APS Group Ltd
APS Apparels Ltd
APS Design Works Ltd
APS Clothing Ltd
APS Holding Ltd

East Faidabad, Dakshinkhan, Uttara, Dhaka

19th March 2014

Observations

Loading – water tanks

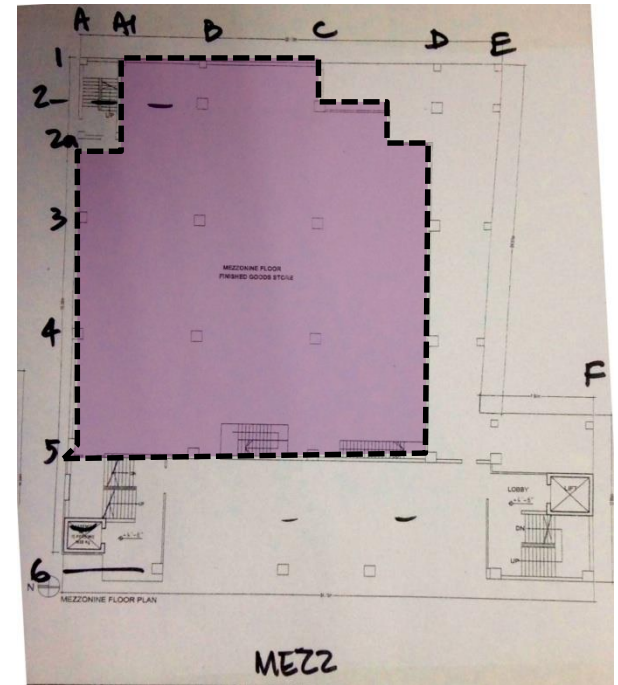
High loading due to water tanks

14no. 2000l water tanks in 2 bays of building roof adds significant load to supporting structure in particular the slabs

Canteen roof support

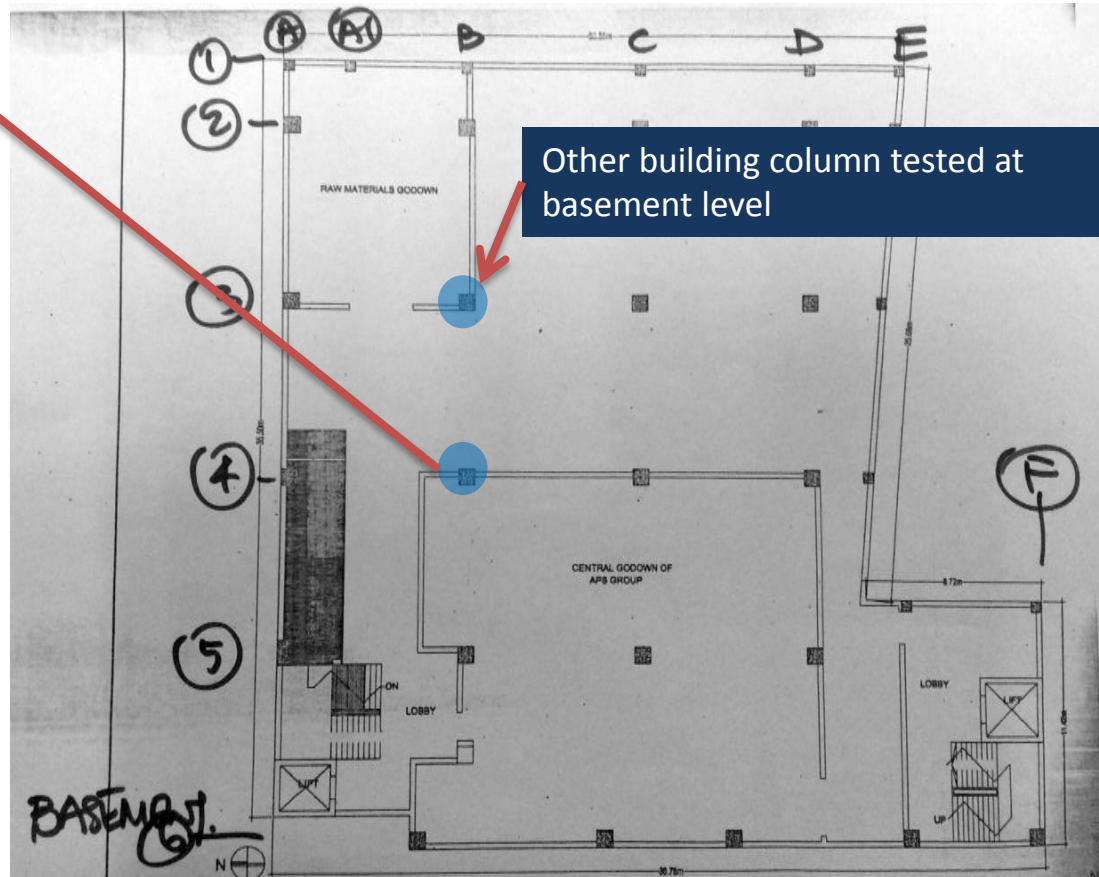
Apparently non-engineered structures: Canteen at roof level

Lightweight steel roof appears to be supported by masonry walls only that may not provide adequate horizontal resistance in a storm event.
